Title: Packaging change notice from LRC

Revised contents: Optimize the packaging box of 7-inch reel of MSL1 product. Change the packing method. Adjust the arrangement of inner box in carton.

变更前: 每箱包装12盒
Before: 12 inner boxes per carton

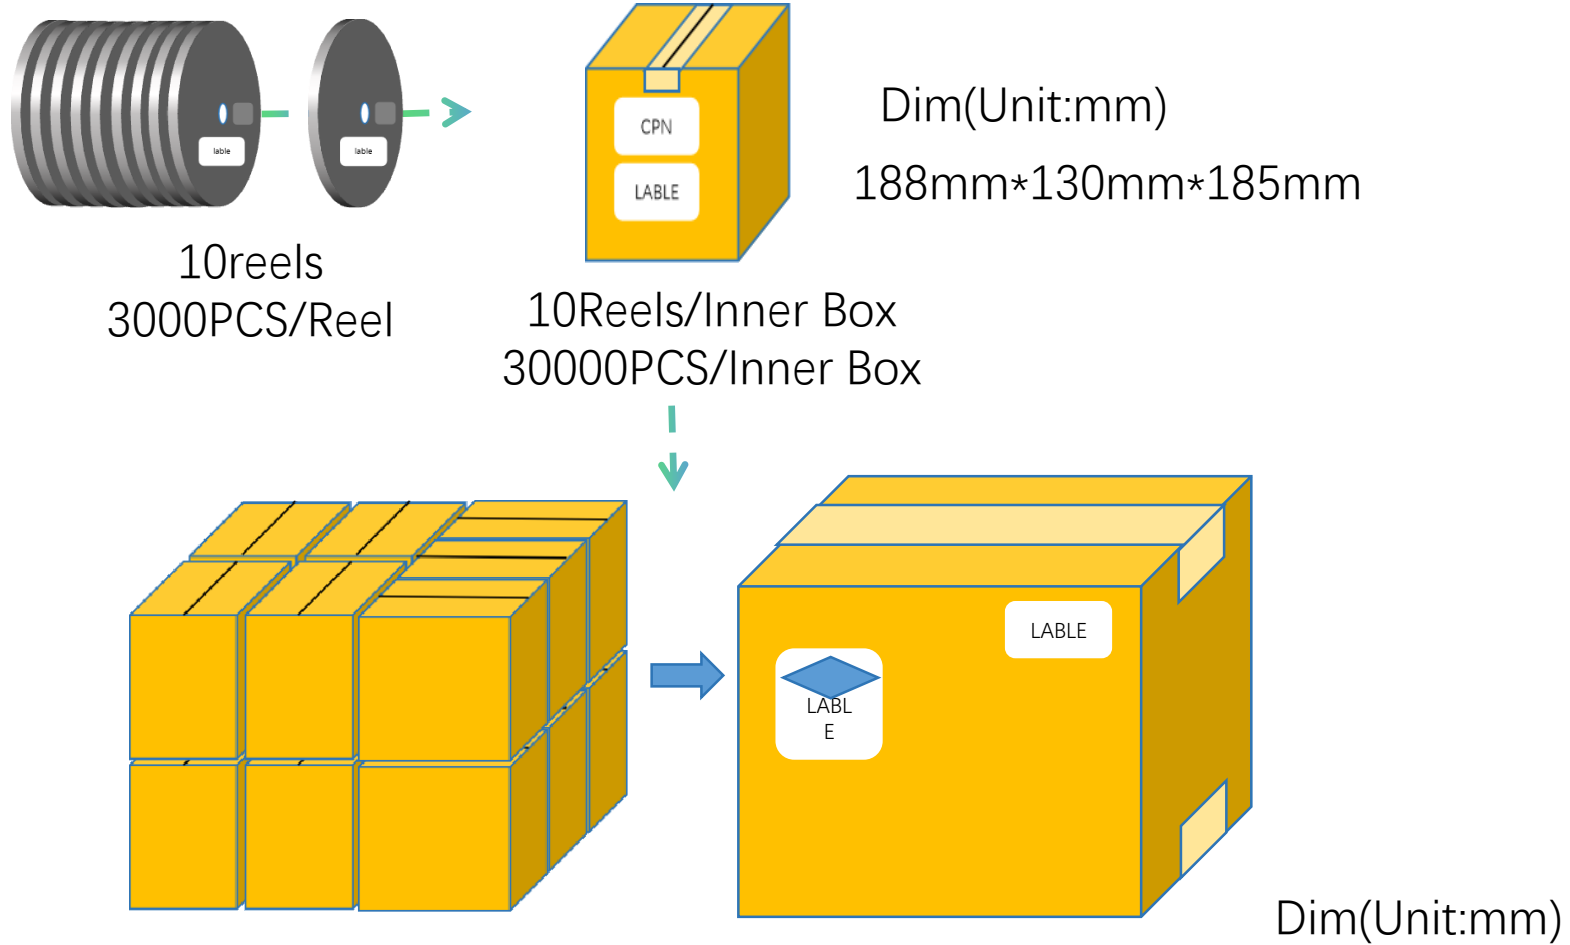
- 最大物流外箱包装: 标准满箱由12盒/箱改为14盒/箱, 各系列产品满装数量对应增加2盒满盒数量;

Maximum carton packaging: The standard packaging of full carton is changed from 12 inner boxes/carton to 14 inner boxes/carton. The quantity of boxes per carton that is fully loaded will be increased by 2 inner boxes. (For example: LMBT3904LT1G, 30K/inner box, a fully loaded carton contains 12 inner boxes, equal to 360K/carton. A fully loaded carton contains 14 inner boxes, equal to 420K/carton.) Please see the pictures as below.

变更后: 每箱包装14盒
After: 14 inner boxes per carton

- 过度期间, 新旧包装盒同装一箱情况, 则按12盒/箱包装。

During the transition period, if the old and new packaging inner boxes are packed in one carton, it is according to 12 inner boxes/carton packed.

The size of carton remains unchanged.
